E8663D-05

# SERVICE NOTE

## E8663D Analog Signal Generator

Instrument failing self-test 704

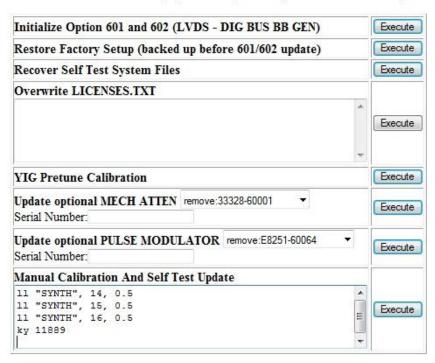
The self-test limits for A6 Frac-N have been updated to avoid possible faulty self-test failure 704. This apply for instrument with option HCC and HAR.

- 1. If you are experiencing self-test failure 704, verify the self test limits by pressing: Utility > Instrument Information/Help Mode > Self Test > View Test Info
- 2. Using the RPG or the up and down arrow keys, scroll to self test 704. Press: Run Highlighted Test
- 3. When the self-test has completed, press: View Details. The lower limits for the following tests should be:-

```
a. 1-1.55 GHz lower = 0.5
b. 1.55-2.4 GHz; lower = 0.5
c. 2.4-3.2 GHz; lower = 0.5
```

- 4. If the self-test limits are correct, continue to troubleshoot the problem using the troubleshooting procedure.
- 5. If the self-test limits are incorrect, first verify that the instrument has firmware equal or higher then C.04.71. If yes, proceed to step (7). If not, update to the latest firmware.
